Alexandria Park Community School

Response to Submissions

NSW Department of Education

April 2018 | Issue C

92-94 BUCKLAND STREET - FIRST TERRACE UNIT

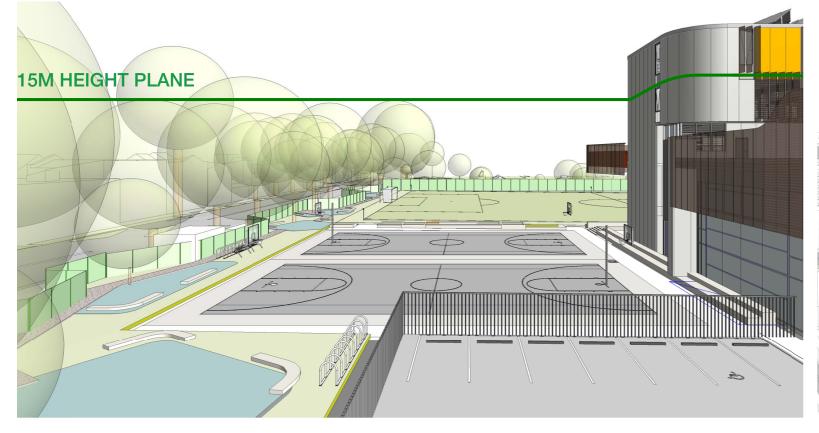
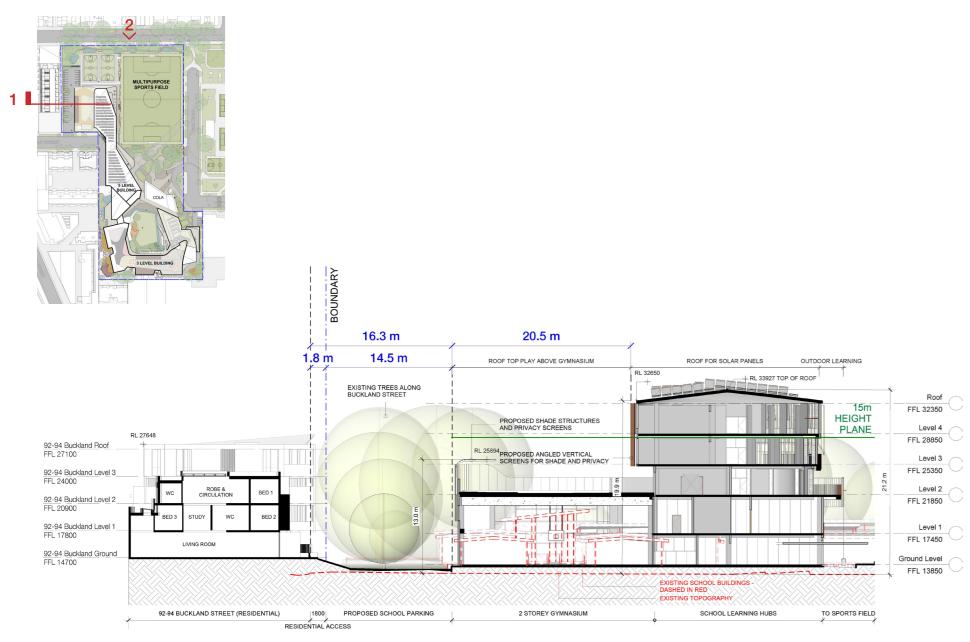
Views from northern terraces are retained, however there are flanking views of the new school building

Views to the east from northern terraces - with flanking views of the new building.

SHADOW ANALYSIS 58 - 60 BELMONT STREET

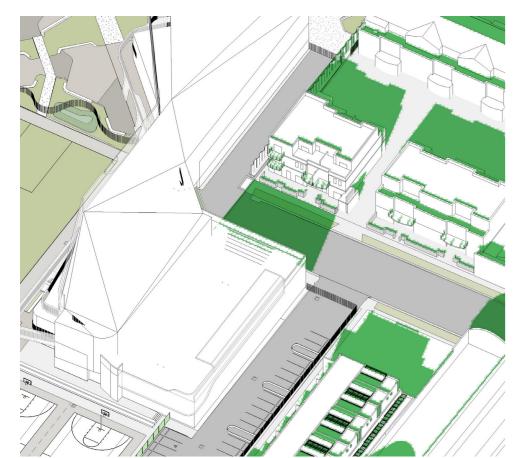
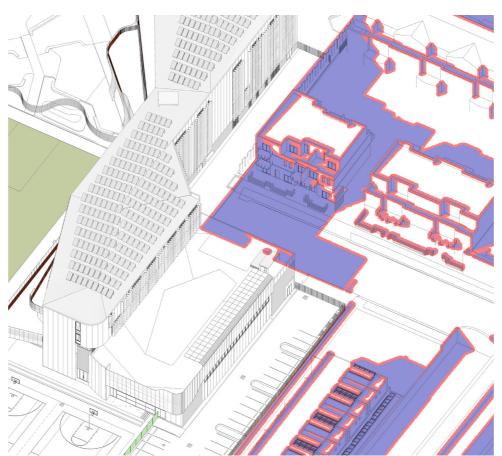
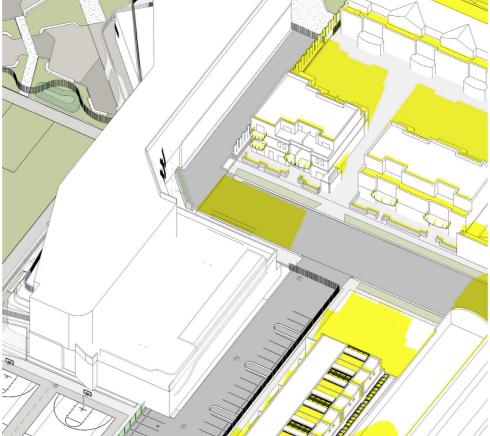
The proposed amendments involves shifting the gymnasium block and associated learning spaces 3m to the north and reducing the height of the gymnasium block along the edge facing Belmont Street. These two changes have greatly improved the solar access to apartments in this development as shown in the diagrams and views in the report.

These diagrams indicate the extent of shadow impact from the current school, the scheme as submitted and complying development. The resultant shadows following the amendment to the gymnasium block is indicated in

VIEW ANALYSIS 58-60 BELMONT STREET

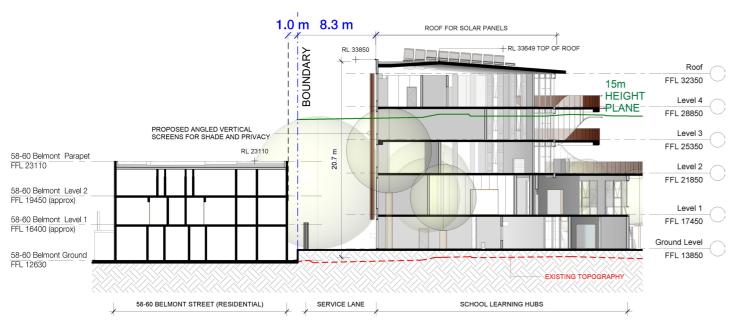
Views to the north are now affected by the new school building, however there remains views of the top of the Buckland Street trees and the sky.

VIEW ANALYSIS 15-17 FOUNTAIN STREET

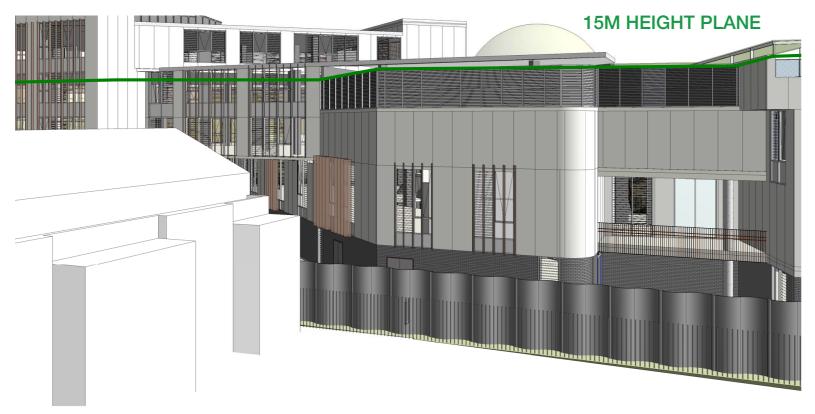
Views from upper level balconies are affected by the new building, however the major impact is the result of part of the new building that is within the complying height plane. There remain distant views of the tops of trees in Alexandria Park. The new building is approximately 40 - 60m distant from the residential building

Views from upper level balconies are affected by the new building, however the major impact is the result of part of the new building that is within the complying height plane. There remain distant views of the tops of trees in Alexandria Park. The new building is approximately 40 - 60m distant from the residential building.

BLOCK C2, D1 AND D2 GROUND, LEVEL 1 AND LEVEL 2 PROPOSED AMENDMENTS

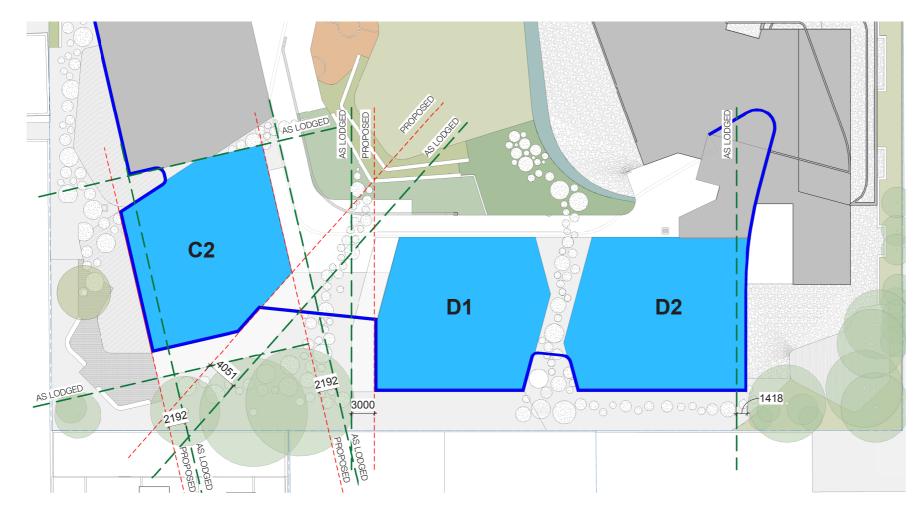
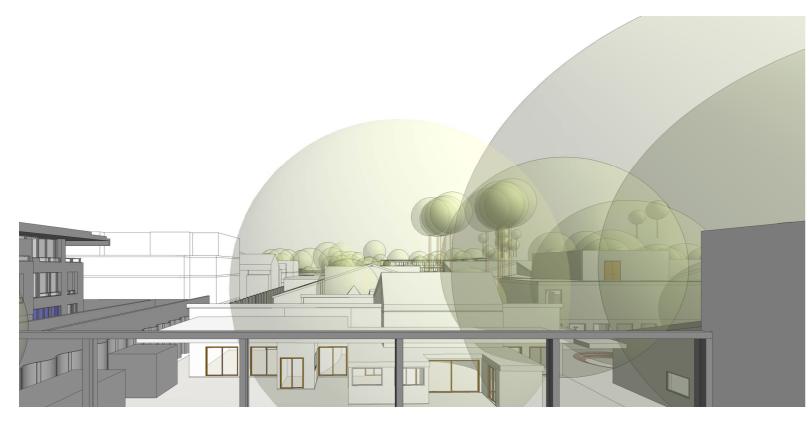
The proposed amendments involve the shifting of the primary school blocks C2, D1 and D2 to create a wider gap between C2 and D1, improving the solar access to units in this development, particularly in the hours through to 2pm.

The proposed amendments involve the shifting of the primary school blocks C2, D1 and D2 to create a wider gap between C2 and D12, improving the solar access to units in this development, particularly in the hours through to 2pm.
